U.S. Department  
of Transportation  
**Research and  
Special Programs  
Administration**

Ref. No. 02-0163

**RE: Addition to Company Logo on Cargo Tank Motor Vehicle**

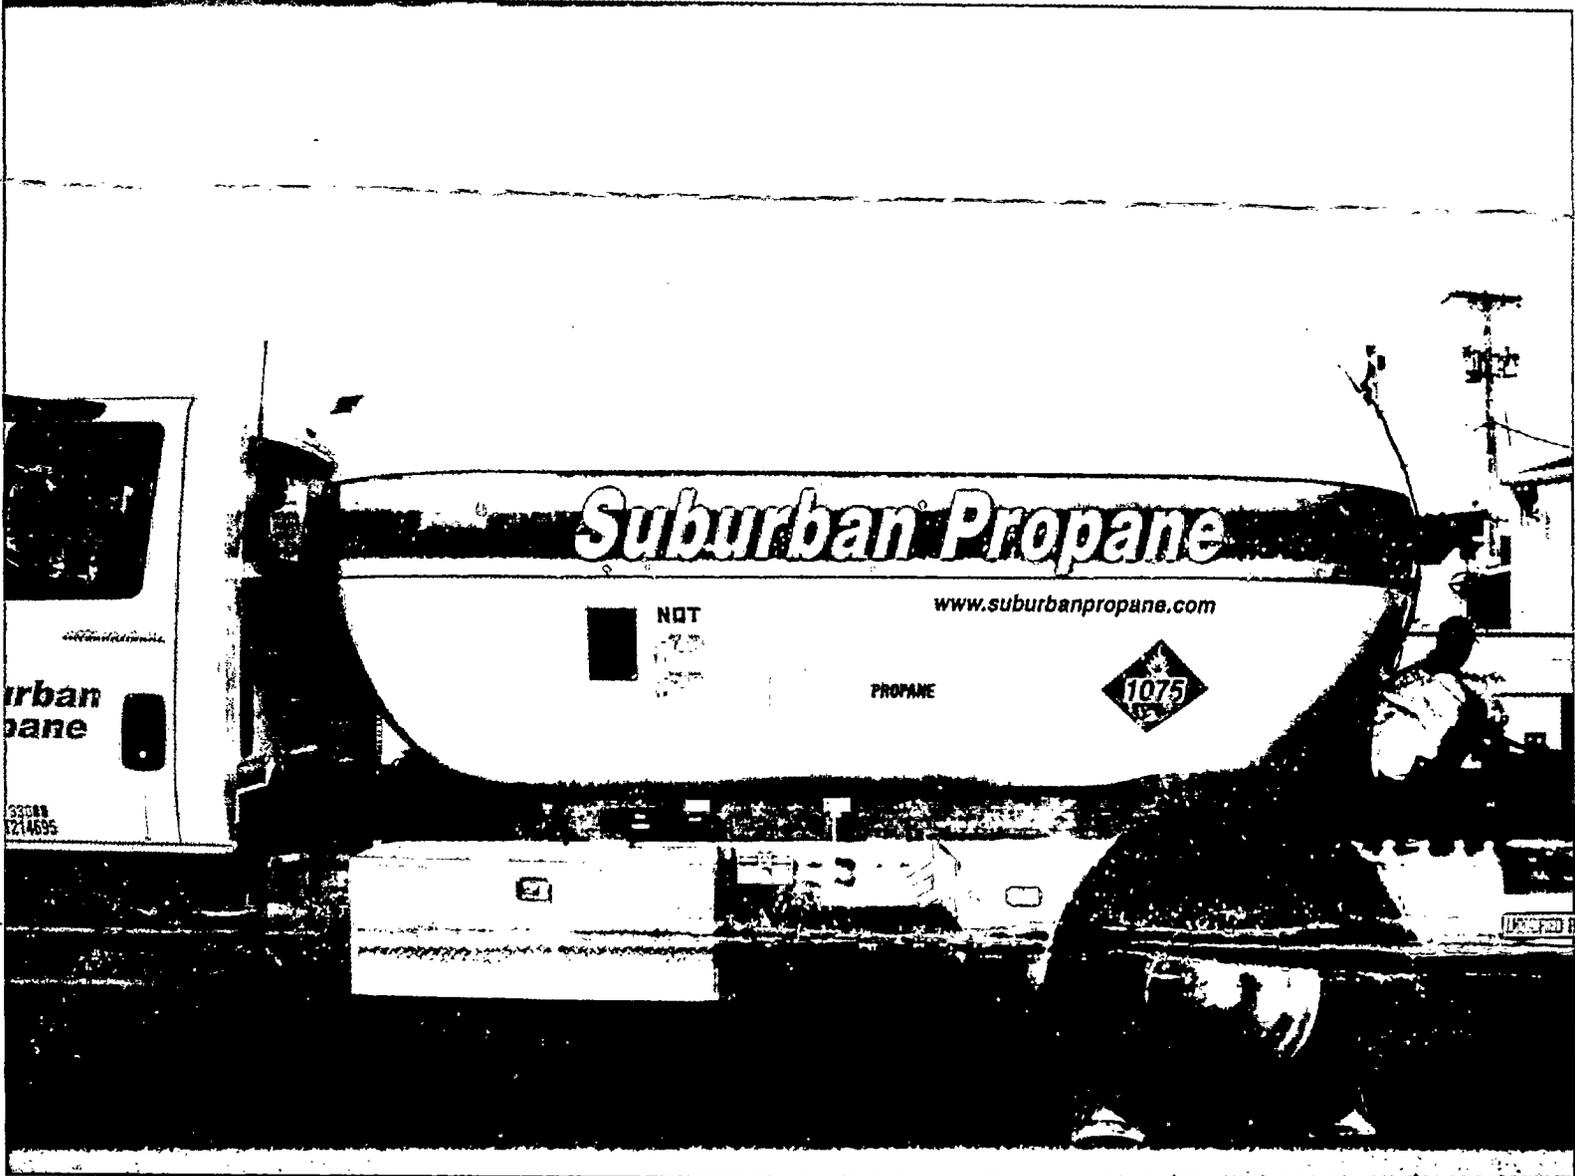
Suburban Propane needs concurrence in writing that the addition of our website address to our existing Company Logo on Cargo Tank Motor Vehicles meets the intent of 178.337-1(d). Attached you will find a photograph of our intended addition to our Company logo. The black letters will be located below our existing red stripe and on the lower half of the cargo tank.

Section 178.337-1(d) identifies that a Cargo Tank is painted white, aluminum or similar reflecting color on the upper two-thirds of the area of the tank. DOT has traditionally allowed the owner's logo and placarding in that area. The additional area covered by the website address lettering is approximately 0.33 square feet of the total 293 square foot surface area of the Cargo Tank.

It is the opinion of this Office that the addition of your website address to your existing company logo on the cargo tanks, as shown in the photograph you supplied, does not conflict with § 178.337-1(d); therefore, you appear to be in compliance with that section.
